This Design & Access Statement has been prepared to support a planning application for a new roof extension, new boundary wall, new double-glazed timber windows and a new air conditioning unit to an existing detached house in 4 Lutton Terrace, London, NW3 1HB.

4.1 RESPONSE TO PRE-APP ADVICE

Pre-application advice was received on 11th August 2021, reference number 2021/3377/PRE The full Pre-App Advice has been re-uploaded with the planning application

Section D-D Pre-App Proposal

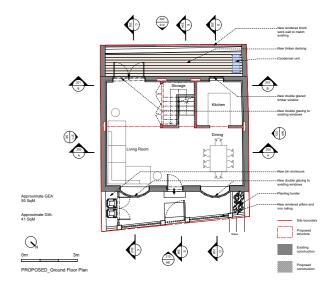
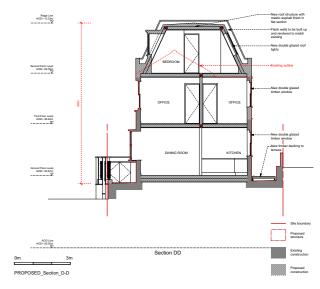
- The three-storey rear extension is stepped and involves the internal reconfiguration with the stairs now located within the middle of the property (and towards the rear). The second floor is also stepped back to provide a reduction in the massing on the first floor.
- The glass windows that the follow the stairway down at the rear do not provide a positive contribution to the property and this vertical glazed facade completely removes the character of the rear elevation. It is accepted there is an existing extension from the 60's which is not of considerable value; however a slightly different design could be put forward to reflect a more traditional character which is present in the surrounding properties and Conservation area itself.

- The pitch of the mansard roof, if possible, should be slightly shallower as to reduce the overall impact and appear smaller in scale. This in turn will reduce the massing to the top of the property which already has three new windows and can be visible.
- To the rear, the proposed roof, glazed link window and setback roof terrace altogether appear cramped and too untidy. If there are different elements on this level, they should be reduced to two elements with the mansard roof continuing over to the roof terrace being the preferred recommendation.

Response: The scheme has been simplified insofar as the rear facade is being retained in its existing location, whereas the staircase is still proposed to be moved towards the middle of the rear wall of the property. The massing at the rear will therefore not increase at all.

The advice regarding the staircase windows has been taken on board, and the window arrangement has been simplified as well as changed, following a more traditional approach, which will be more in keeping with the cottage style nature of the building and the character of the surrounding properties.

The second floor extension will still be set back at the south corner, and therefore achieve a reduction in the massing, as well as create additional amenity space without intruding on the neighbours' privacy.

Response: The pitch of the mansard roof has been decreased from approximately 70° to 65°, which is about the minimum pitch that makes habitable occupation on this floor possible.

In line with the simplification of the rear part of the building, the roof shape has been adjusted as well, now only consisting of one continuous mansard roof over the bedroom and staircase, cut out at the roof terrace. A subordinate, lower flat roof is being introduced over the roof terrace to provide sun protection and prevent overheating.

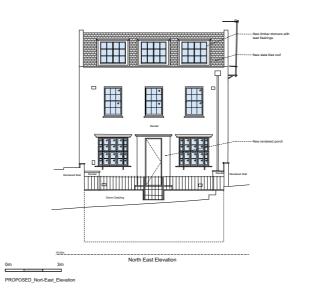
- The principle of mansard roof windows to the front are considered acceptable and are positioned in the correct place (in line with windows on the first floor).
- The window size should be reduced in order to be more sympathetic to the existing windows and overall building.

Response: The width of the dormer windows has been reduced, so they now align with the first floor windows below.

North-East Elevation Pre-App Proposal

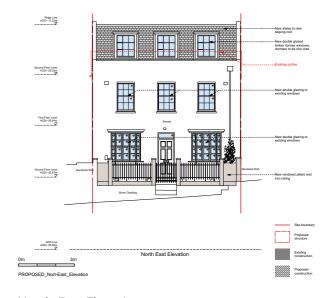
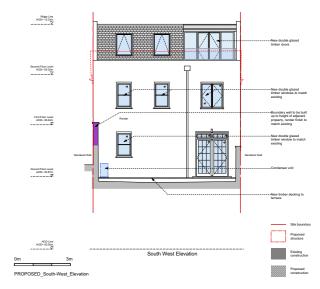
The site is significantly constrained in that the garden is very small and the shared boundary with nos. 47-51 Flask Walk and 1-10 New Court is very close to the building. This context means that the occupants of nos. 45-51 Flask Walk already suffer from a sense of enclosure and reduced daylight and sunlight. The proposed rear and roof extensions would be likely to compound these issues by increasing the height, width and massing; however it is not clear to what extent, because the position of the property is such that the difference may not be significant. Furthermore the roof terrace may provide overlooking issues for the rear gardens on Flask Walk. A daylight and sunlight study should support any forthcoming application as well as detailed plans or graphics to demonstrate that the amenity impacts are not significant.

Response: The massing at the rear of the building has been reduced and is now following the existing outline. The privacy of nos. 47-51 is safeguarded by the setting back of the roof terrace and the raised flank wall, which will prevent overlooking. A daylight and sunlight study has been carried out, which shows that all neighbouring windows (that have a requirement for daylight or sunlight) pass the relevant BRE diffuse daylight and direct sunlight tests. The development also passes the BRE overshadowing to gardens and open spaces test.
